**NOTICE OF INTENT TO COMMENCE LARGE MINING OPERATIONS &  
MODIFICATION OF PLAN OF OPERATIONS**

**LISBON VALLEY COPPER MINE**

M/037/0088

**Introduction Table 1 – Comments**

Post Reclamation Hydrology - C Dump

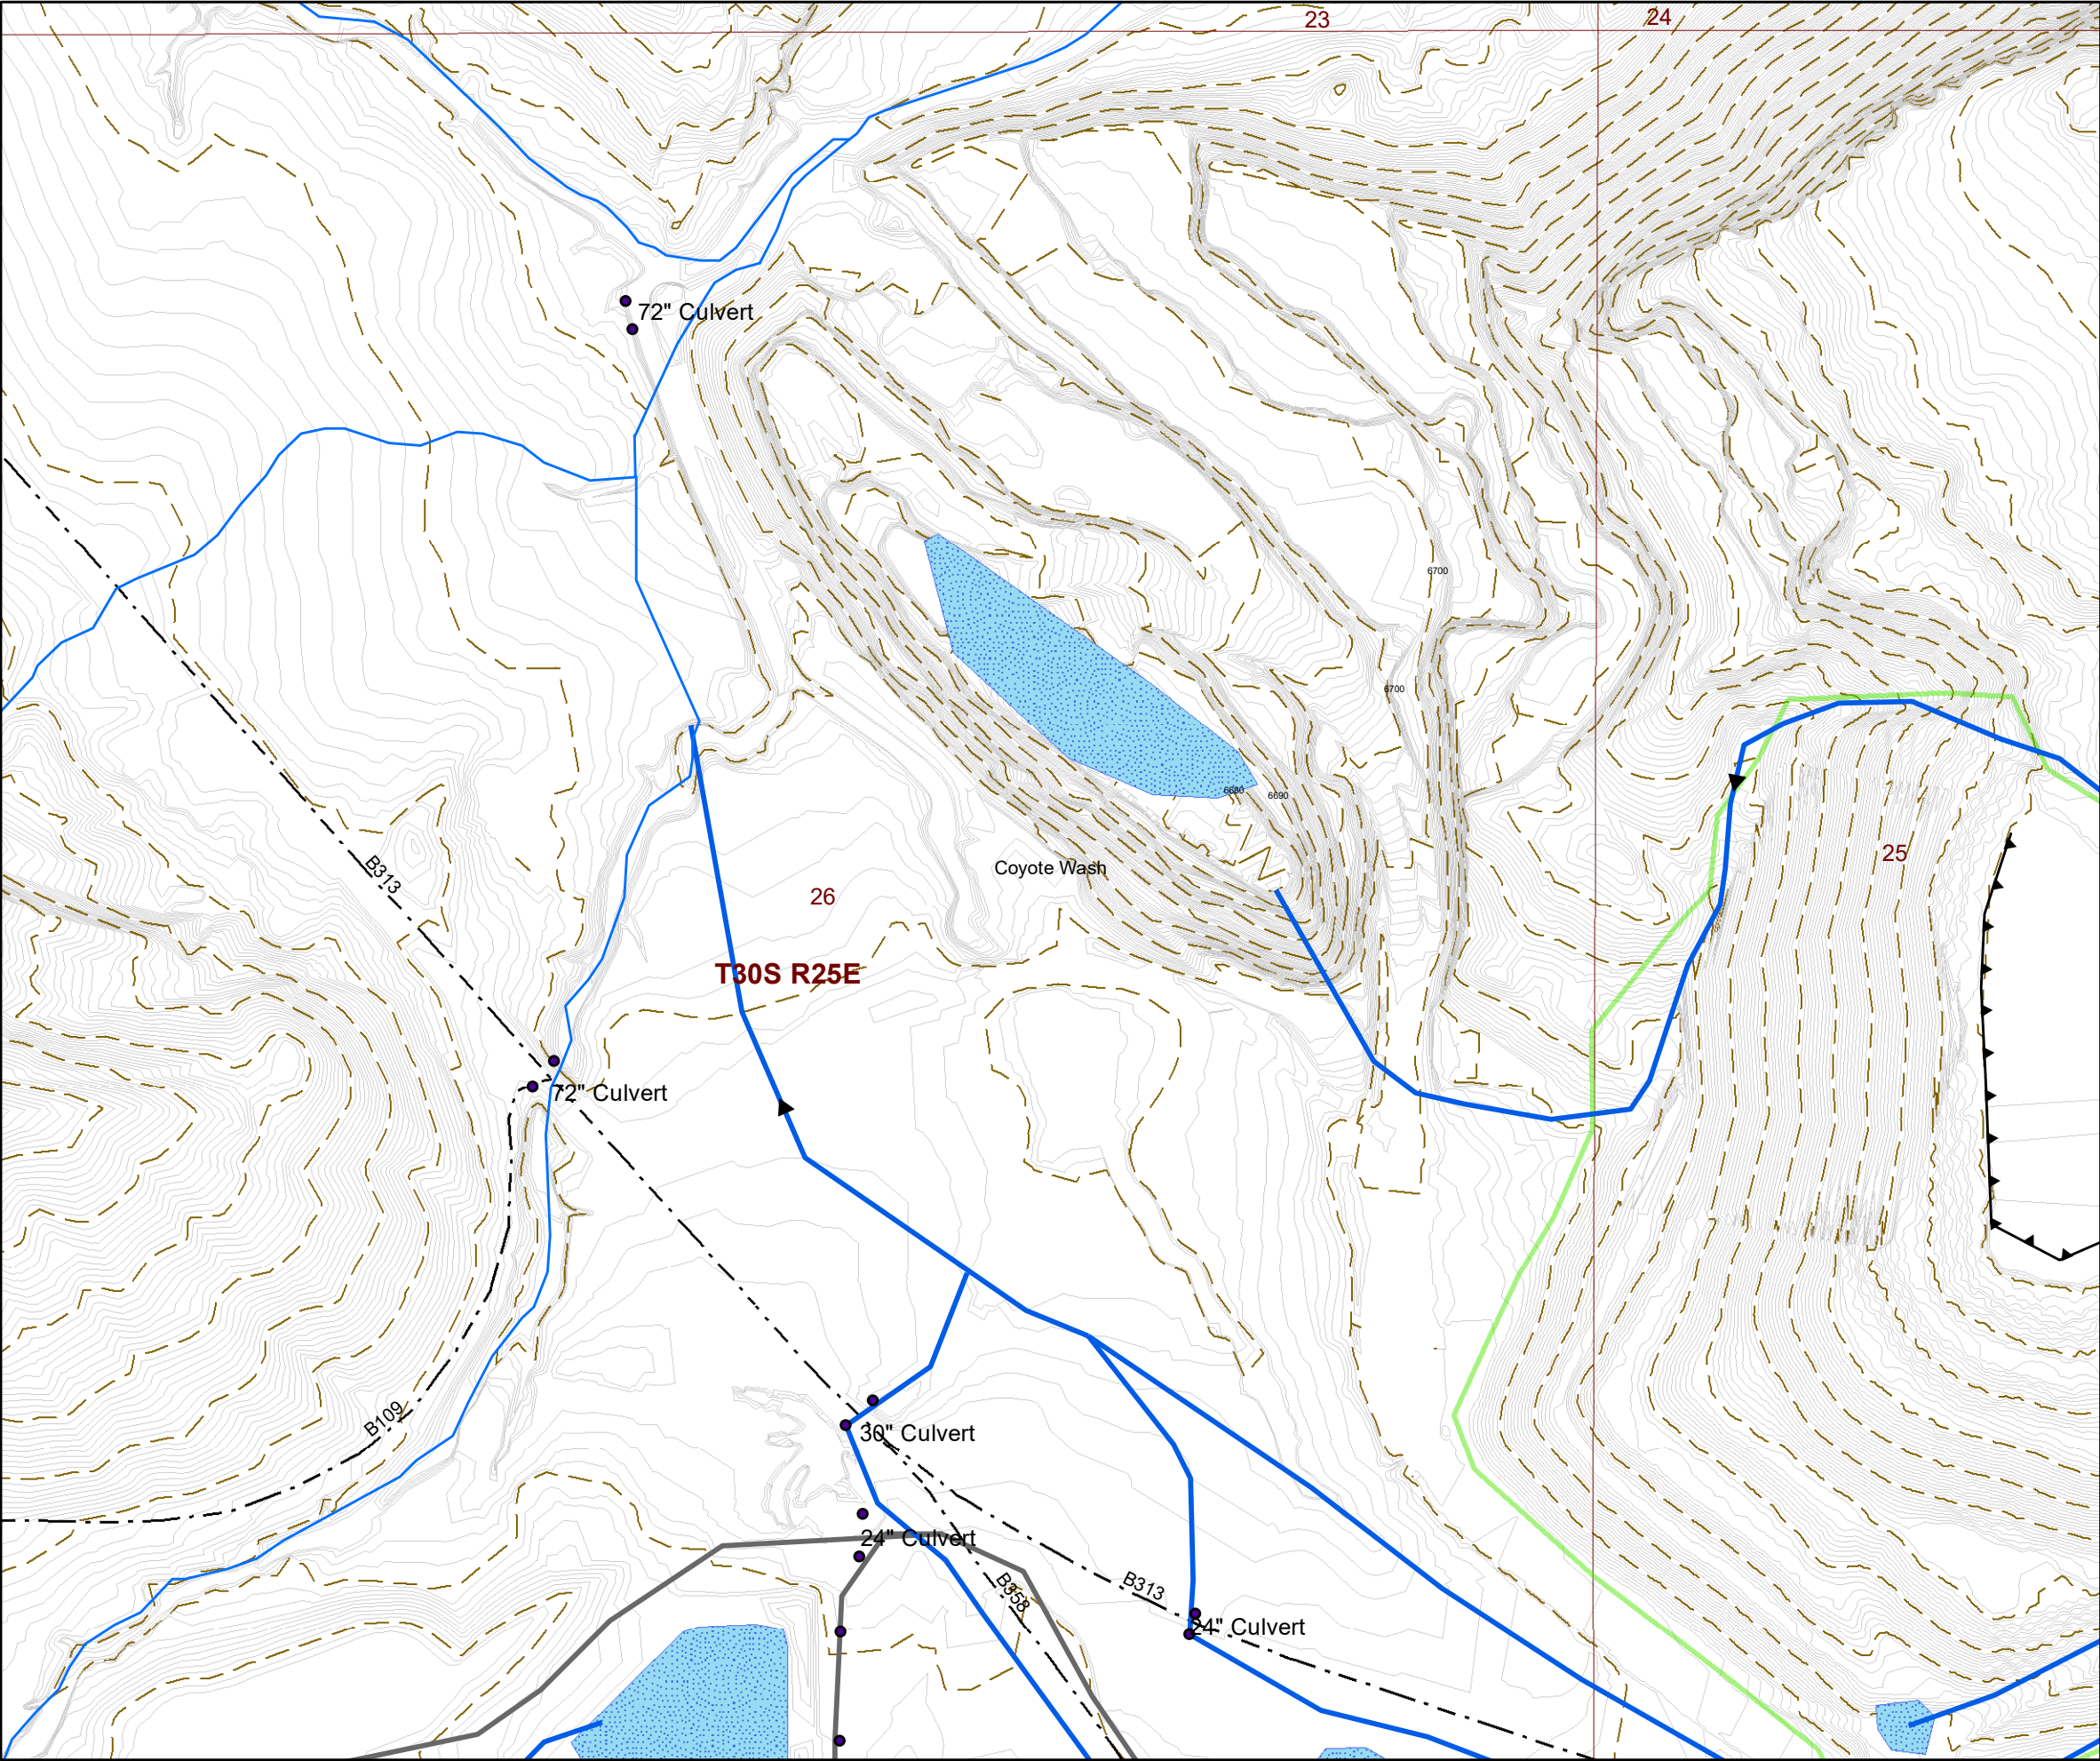
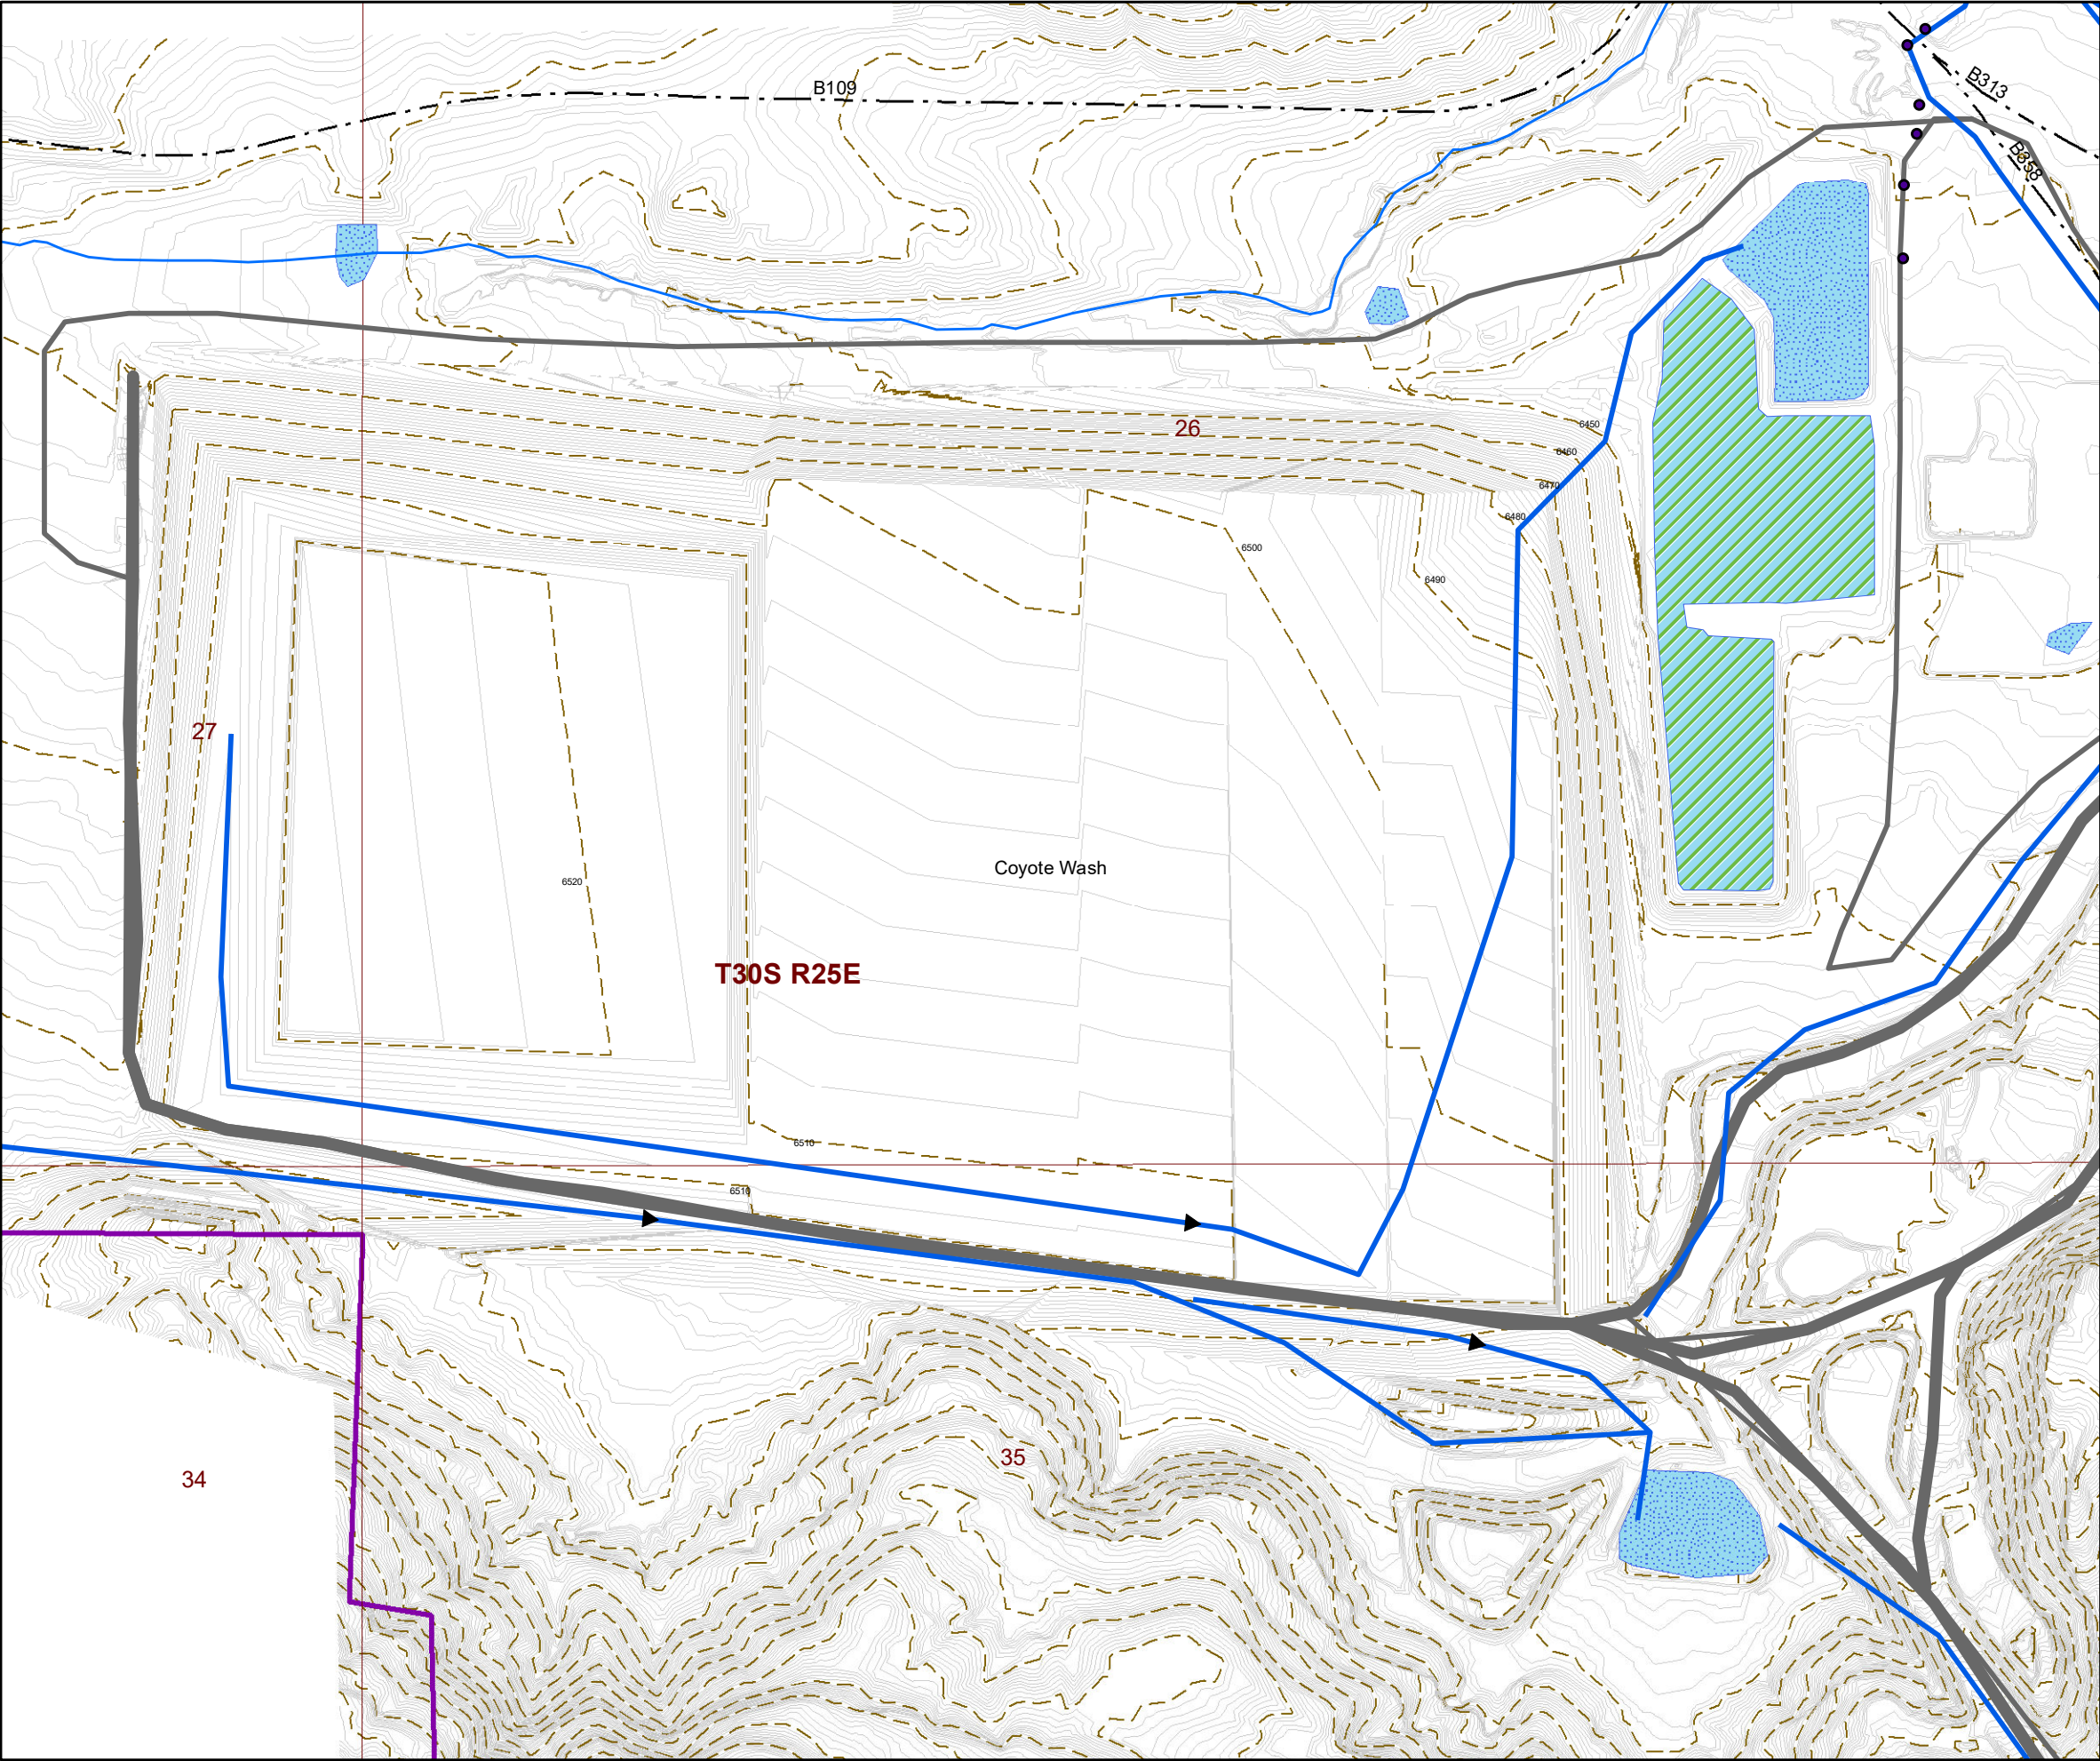
UDOGM Comment	Company Response	Response Location
Map 4, Hydrology – A new Map 4 has not yet been provided. As indicated in previous reviews, the existing Dump C channels are not acceptable in their current form. Watershed boundaries and associated acres are not included in previous maps. GTO areas planned for disturbance that may affect the grade and stormwater flow should be included within disturbance boundaries on this and other maps.	Map 4 has been updated to include the hydrologic features per the aerial flights and drainage processing performed by LVMC in February 2020. Modified drainage patterns have been mapped out for installation of riprapped drainage channels and associated catchment basins.	Appendix C
<p>Map 5, Reclamation Treatments (all maps) – Consistent with the discussion in section 110 (reclamation plan), include the following:</p> <ol style="list-style-type: none"> <li>1) Identify berms around pit highwalls (not just at access points), as requested above. Fencing alone is not considered adequate for long-term public safety.</li> <li>2) Indicate whether pond HDPE liner will be removed or modified (including to receive any graded heap leach pad slopes)</li> <li>3) Identify the depths of soil replacement, as well as compacted clay and inert waste rock thickness on the heap.</li> <li>4) Identify soil replacement on haul roads. Ripping alone is not likely to be successful since the roads probably contain contaminants that would inhibit vegetation.</li> <li>5) The Division recommends a single ripping of spread soil on the contours, since dozer track marks from grading are less likely to resist erosion over slope lengths such as these.</li> <li>6) Indicate that the landfill will be reclaimed consistent with Department of Environmental Quality (DEQ) requirements.</li> </ol>	<ol style="list-style-type: none"> <li>1) Berms have been identified around all pit perimeters. These are seen on the modified Map 5, Appendix C.</li> <li>2) Pond liner already ties into the leach pad liner via the east drainage ditch. No liner modifications are required for the ponds to receive graded leach pad slopes. Regarding the areas on the north where the slopes are not yet 2.5H:1V, these slopes are to be re-graded in 2021 in preparation for another lift. Although current leach pad slopes do show some areas that are not operationally 2.5H:1V, all slopes on the leach pad are capable of being re-graded to an overall 2.5H:1V slope when taking into account the pipe ditch at the toe of the pad slopes.</li> <li>3) Please see Map 5 for reclamation media layers.</li> <li>4) Please see Map 5 for reclamation media layers. Placement of topsoil on haul roads will only be performed if excess topsoil is available and if the roads do not serve a post-mine land use. Further, as the roads at the mine have not been treated with surfactants, very low risk of ‘contaminants’ exist on the roads, as all vehicle maintenance is performed at the designated Truck Shop.</li> <li>5) This is noted. Please see notes on Map 5 for reclamation practices.</li> <li>6) This language is located in Section 110 as well as on Map 5.</li> </ol>	Appendix C Section 110 Appendix I
